**Aldi Store, Hostmoor Avenue, March****CCC Ref: FDC 1991****TRANSPORTATION COMMENTS****PREPARED BY: Transport Assessment Team****AUTHOR: Hannah Seymour-Shove****CHECKED BY: David Allatt****DATE: 8<sup>th</sup> December 2020****Background**

These comments concern the TN05 - Existing Traffic Data Assessment dated 20<sup>th</sup> November 2020 produced by Connect Consultants Ltd. The proposals comprise the development of a new Aldi discount foodstore with GIA of 1881sqm on Hostmoor Avenue in March.

**Aldi Store, Hostmoor Avenue, March****CCC Ref: FDC 1991****TRANSPORTATION COMMENTS****PREPARED BY: Transport Assessment Team****AUTHOR: Hannah Seymour-Shove****CHECKED BY: David Allatt****DATE: 11<sup>th</sup> February 2021****Background**

**Aldi Store, Hostmoor Avenue, March****CCC Ref: FDC 1991****TRANSPORTATION COMMENTS****PREPARED BY: Transport Assessment Team****AUTHOR: Hannah Seymour-Shove****CHECKED BY: David Allatt****DATE: 9<sup>th</sup> April 2021****Background**

## **APPENDIX 5 – PROPOSED A141/HOSTMOOR AVENUE SIGNAL SCHEME LAYOUT**

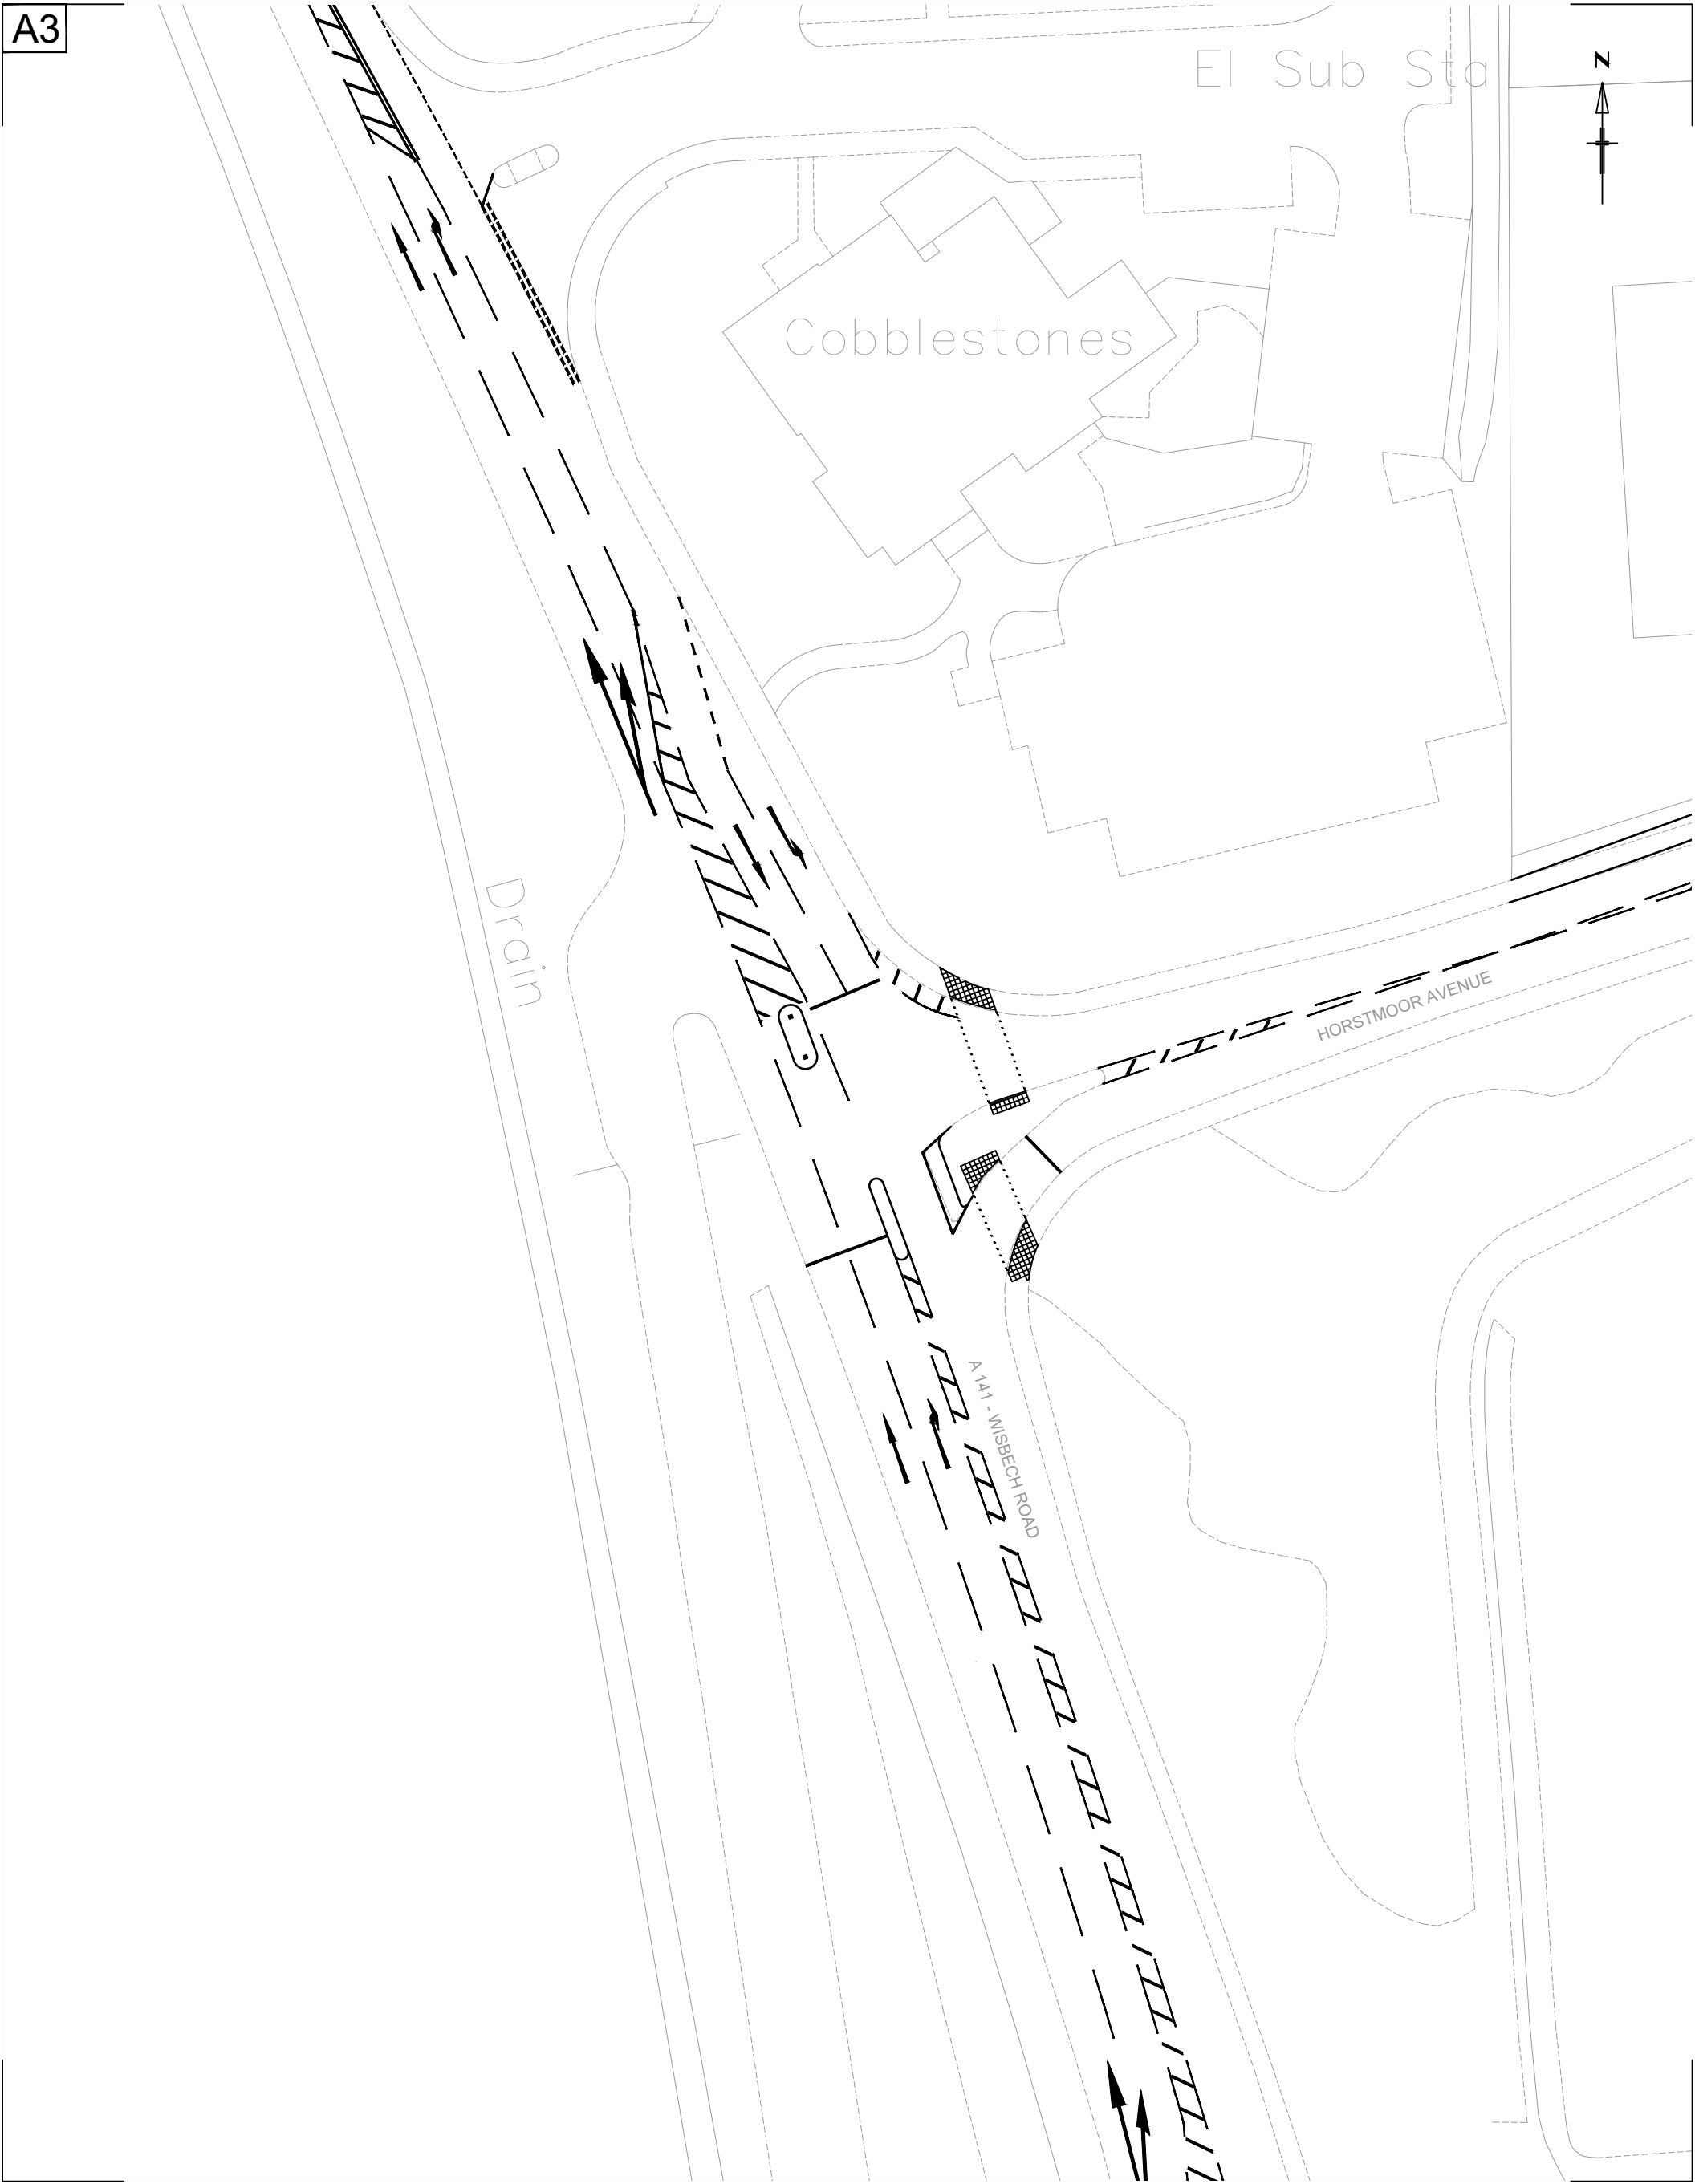
- *The McDonalds access as indicated on the flow diagram is very close to the A141. These stores have been shown to cause great disruption to the network due to queuing back, this has been especially an issue during the recent Covid times. The right turn from Hostmoor Avenue into the McDonalds could experience queueing on Hostmoor Avenue going back onto the A141.*

- The flow diagrams only show a left turn from Hostmoor Avenue and not a right turn. This looks to only indicate what the flows would be with the new signals, so have the existing right turn flows been transferred to the left? The developer should provide a comparison of the existing turning movements at this junction in the peak periods with the anticipated future turning movements at this junction to determine the number of existing right turn movements from Hostmoor Avenue which will be re-routed to turn left to then U-turn at roundabout as part of this signal scheme. I am aware of some drivers currently turning left out of Hostmoor Avenue to U-turn at the roundabout as this is safer and easier in peak times than turning right out of the junction.

- General proposal layout - Somebody leaving Hostmoor and wanting to head north up the A141 are going to be forced out left. The suggestion is that they will then use the roundabout to U-turn. If this is the chosen option, to prevent drivers from coming out left and then performing a dangerous manoeuvre to turn immediately right after the island and approach the northbound lane to the signals to avoid U-turning at the roundabout, then an island would be required connecting all the way to the roundabout, with a barrier to stop people driving over the central kerb. A Safety Audit is likely required at the planning application stage to assess the safety of this junction design.

- The forced left turn also complicates any future expansion into the land opposite which would require a fourth arm. If a fourth arm was added to the junction in the future, the junction would likely be heavily over capacity. It would be better to access development on the land opposite from another location.

- At a basic level it looks like the right turn has been taken away from Hostmoor Avenue because if left in the design then the signals would need another stage, leading to the junction being over capacity.

- Evidence would be required to determine whether the additional Hostmoor Traffic U-turning at the roundabout below would cause capacity issues at such roundabout.

Additionally, comments made by our Cycle Team concerning the layout of the proposed signal scheme are as follows: *“At the moment I’m not sure that Wisbech Rd is a shared use path (can’t see any signs) but it seems that people use it as such so the demand is there. My suggestion would be that the footway should be widened at the crossing points so that people can get past others waiting to cross. Ideally this would be a one-stage crossing with a refuge in the middle (so that informal crossings could still be undertaken) but it may be that the width needed for larger vehicles to turn in and out means that the crossing would be too wide for this. Good to see that guard railing is not proposed”.*

At the meeting dated 22<sup>nd</sup> March 2021, the option of a simple dedicated left slip out of Hostmoor Avenue onto lane 1 of the A141 was discussed. CCC await to see the outcome of the initial works undertaken by Connect to determine whether such scheme is feasible.
